Integrated Resource Plan
Public Advisory Group: Public Input and Requests
Meeting Date: July 6, 2017

I. Questions submitted in writing at the 7/6/17 meeting to be responded in writing by EPE

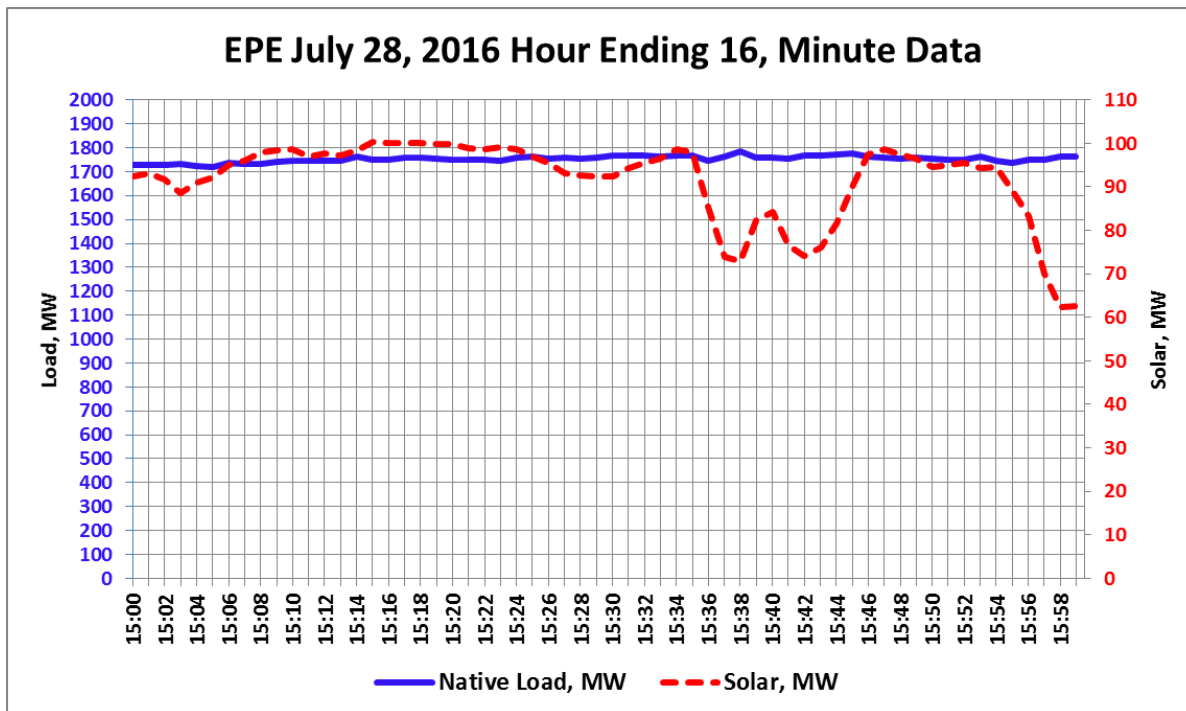
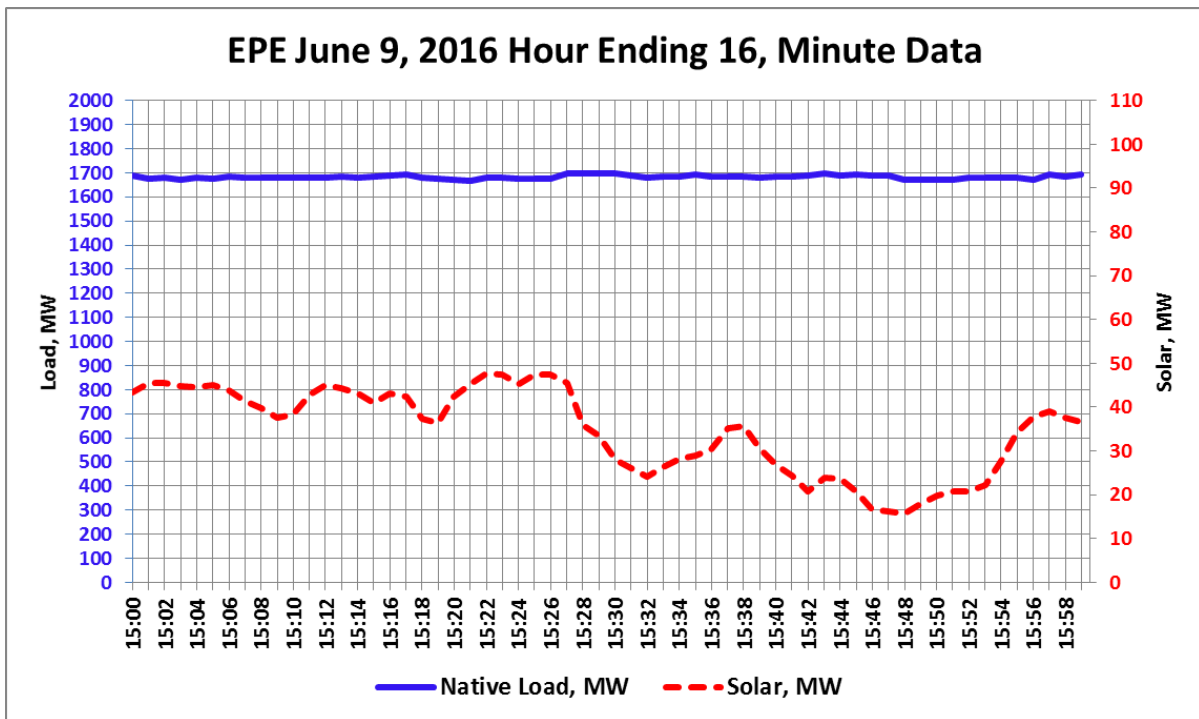
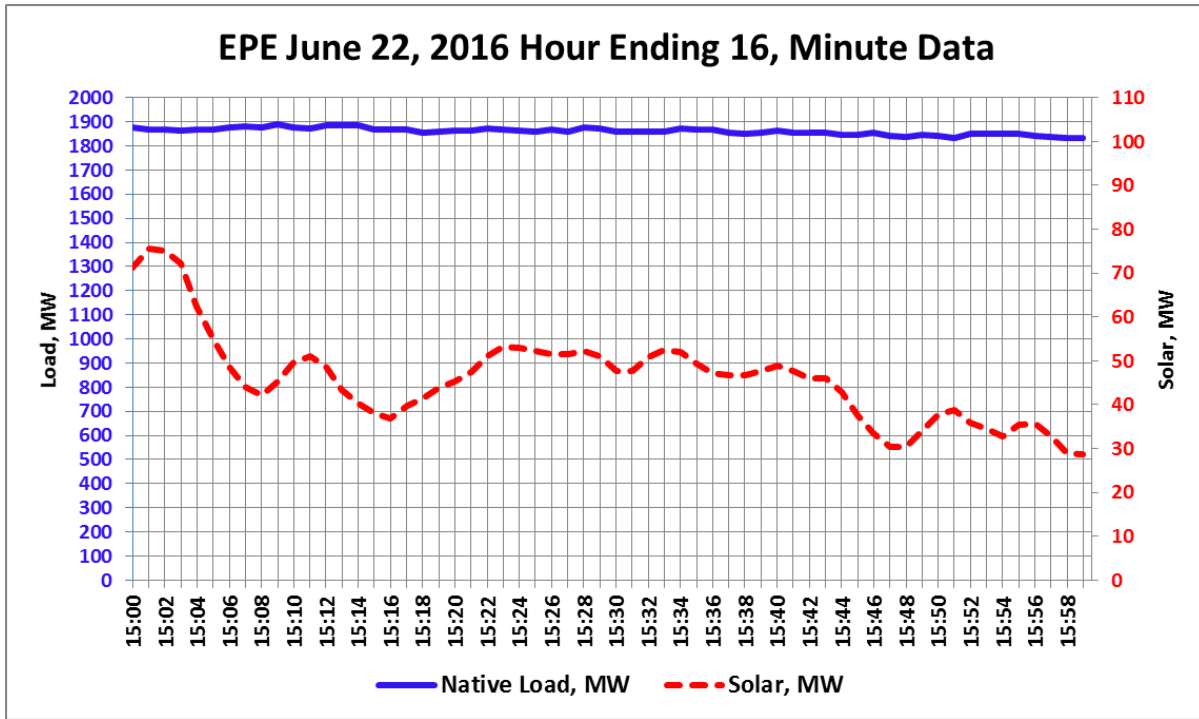
PAG Q15:

What are the transmission constraints that will be modeled?

Transmission constraints will be discussed during the 10/5/17 meeting.
